<b>Notice of Allowability</b>	<b>Application No.</b>	<b>Applicant(s)</b>	
	10/562,280	LOH ET AL.	
	Examiner	Art Unit	
	William J. Klimowicz	2627

DO  
Replacement Sheet  
Reply to Office Action of October 2, 2007

Serial No. 10/562,280

FIG.2

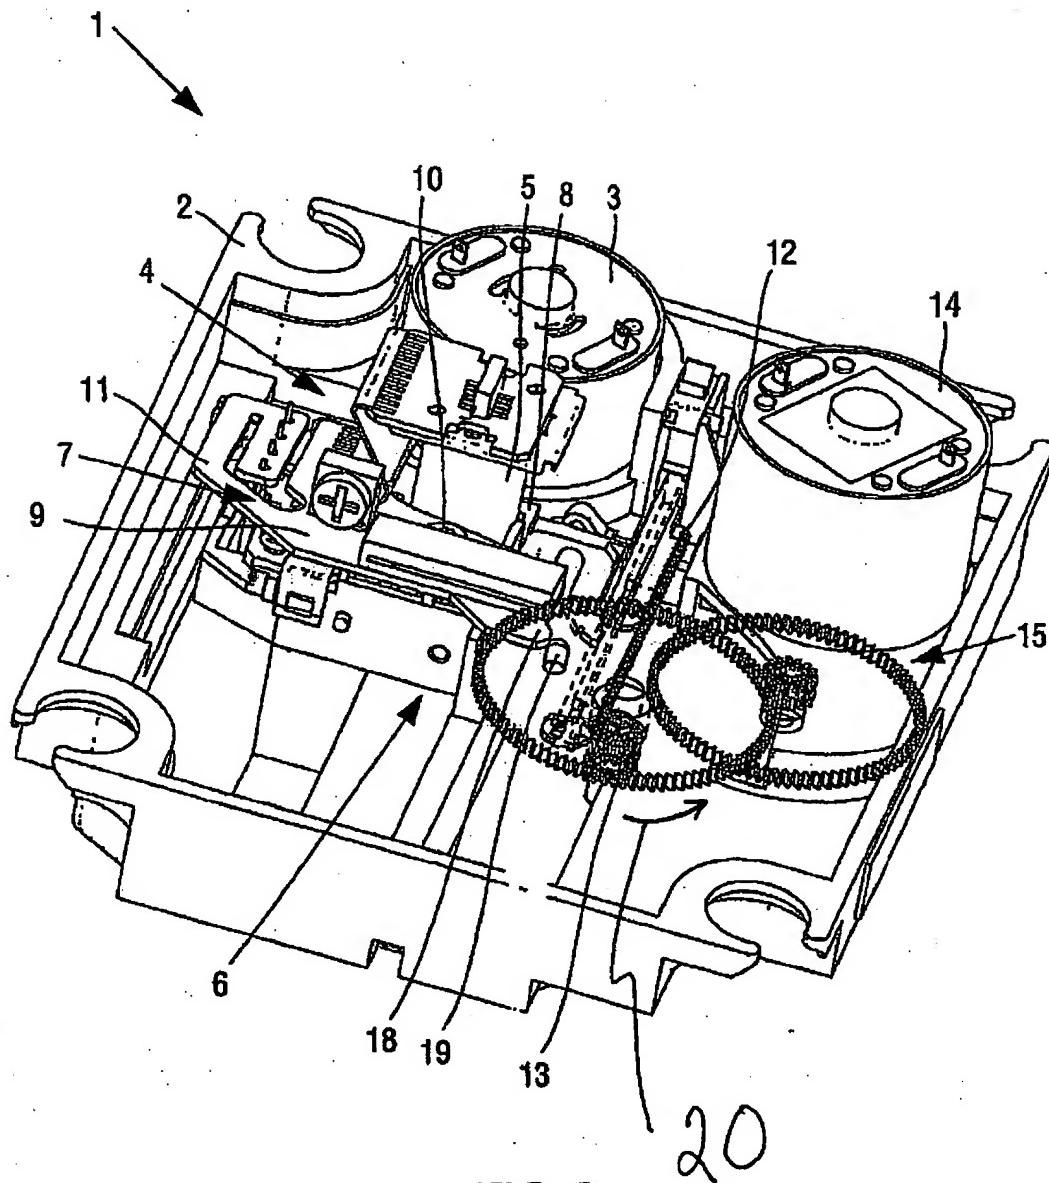
The drawings were received on January 2, 2008. These drawings are *disapproved*, since the direction of arrow 20 appears to be in the wrong direction. At stated at page 5 (lines 11-16) of Applicants' specification (emphasis in italics added):

However, as shown in Figure 2 of Applicants' drawings, the home position is depicted wherein the slide (8) is closest to the spindle motor such that engagement members (18) and (19) are *proximate* each other. This would require that the direction of arrow **20** be in a *clockwise direction (in the context of Applicants' disclosure description)*, as opposed to the counterclockwise direction depicted in the Applicants' Replacement sheet filed on January 2, 2008.

As such, the Replacement drawing has been disapproved until a correct directional arrow (20) can be shown.

Not  
approved
